NSLPP MEETING HELD ON 01/11/2023

ADDRESS: 7 Ryries Parade, Cremorne

APPLICATION NO: DA 81/23

PROPOSAL: Demolition of existing dwelling and construction of a new two storey dwelling

Figure 5 – Landscape Plan

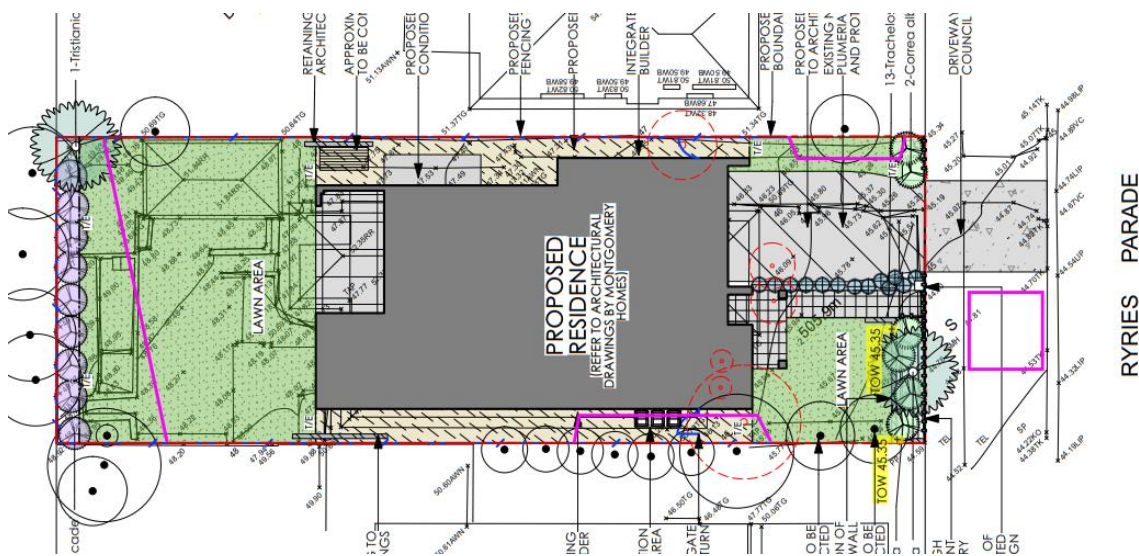
The proposed Elaeocarpus reticulatus shown to be planted within the front setback shall be replaced with Tristaniopsis laurina (75l), 1 x Camellia sasanqua (75l) shall be planted in the council verge in front of 7 Ryries Parade and ground levels within the TPZ of all protected trees shall be retained as existing.

Planning Comment: the amended plans with a greater front setback ensures that Plumeria(s) within the front setback can be maintained. The amended landscape plan proposes a *Tristaniopsis laurina* within the front setback as per directions from Council's Landscape Development Officer.

Figure 16 – Annotated Section A, Dwg No. A7 Rev 2d

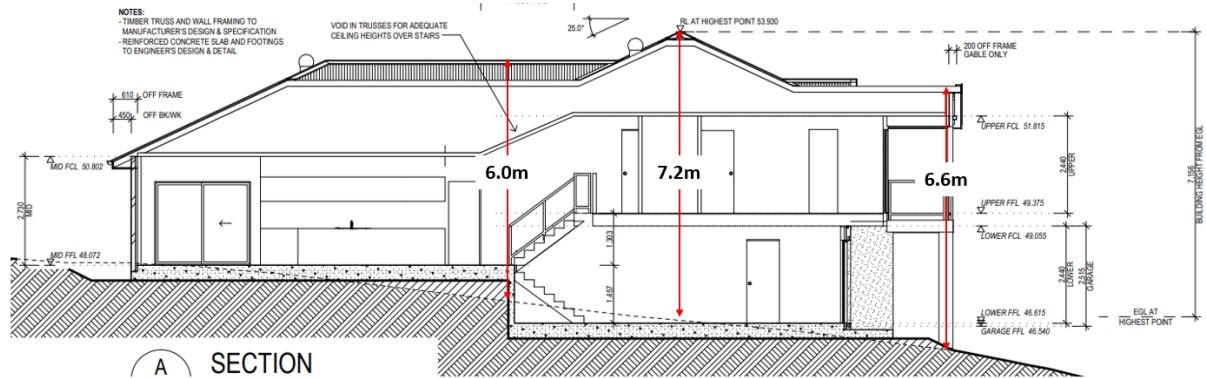
The proposed works would have a maximum height of 7.2m that complies with the permissible height limit of 8.5m in accordance with clause 4.3 in *NSLEP 2013*.

Figure 17 – Annotated Section A detailing in red excavation and in yellow fill

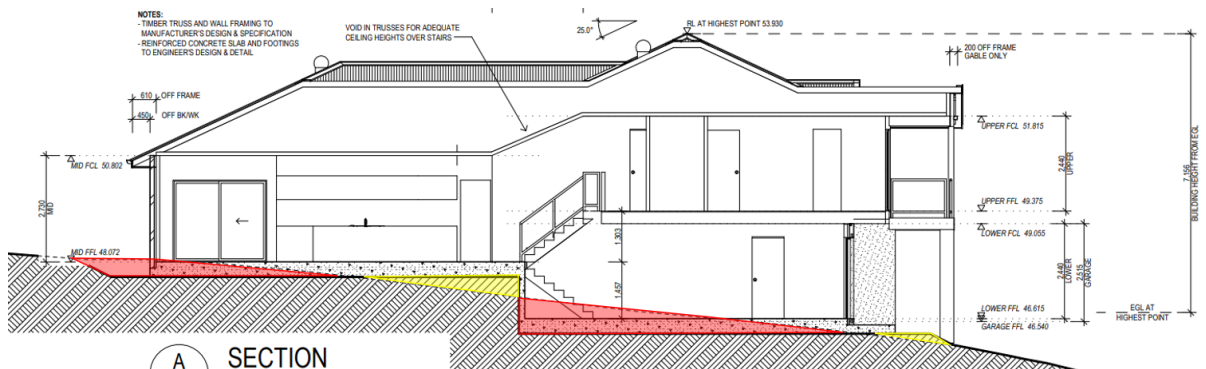
The proposal involves some earthworks to construct the new dwelling comprising both cut and fill due to the topography of the site. The site is noted for having a topography which gradually rises from the front boundary facing Ryries Parade to the rear boundary of 4-5m. However, the dwelling is designed with split levels which helps to minimise the extent of earthworks required (cut and fill highlighted in the section below).

The dwelling due to the split level design and proposed 910mm side setback to the south western boundary and 1.5m side setback to the north eastern boundary ensures that the development is likely to have a minimal disruption on the soil stability of the locality, the amenity of adjoining properties and the development is generally sited on a similar footprint to the existing dwelling maintaining much of the site and adjoining site’s vegetation therefore the development is considered compliant with matters for consideration in Cl. 6.10(3) of NSLEP 2013.

Figure 20 – View through ground level window at 5 Ryries Parade towards proposed dwelling (existing dwelling edged in blue), Mona Building Designs

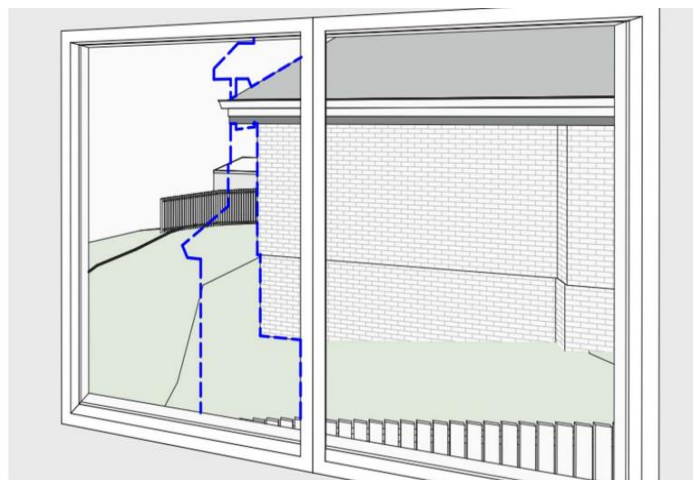
- The extent of impact from the proposed replacement dwelling is considered insignificant noting the development has been amended to have an increased front setback to align with that of 5 Ryries Parade.

Figure 32 – June 21 12pm shadow diagram (Dwg No. A11, Rev 2d)

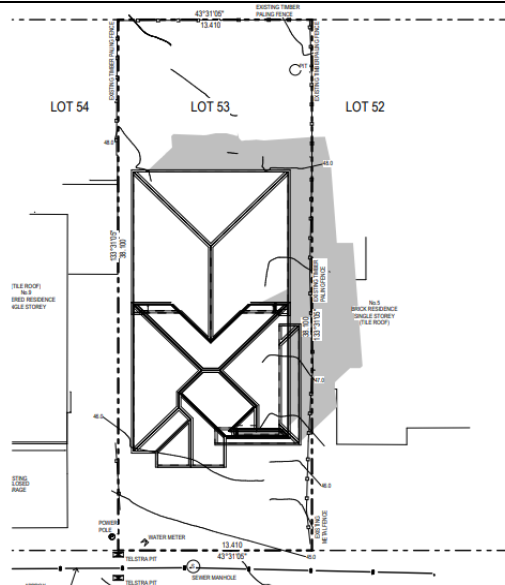
In summary, the winter shadow diagrams confirm the dwelling is designed and sited appropriately to provide a minimum of 3 hours solar access at mid-winter between the hours of 9.00am and 3.00pm to windows of main internal living areas and principal private open space of both the subject site and adjoining properties satisfying Provision P1, s1.3.7 of NSDCP 2013.

Figure 33 – June 21 3pm shadow diagram (Dwg No. A11, Rev 2d)

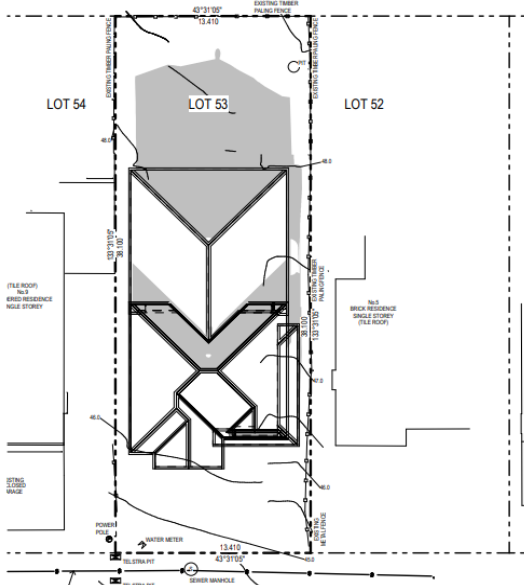
At 3pm shadows cast will have no impact to adjoining properties with shadows falling over part of the rear garden of the subject site.
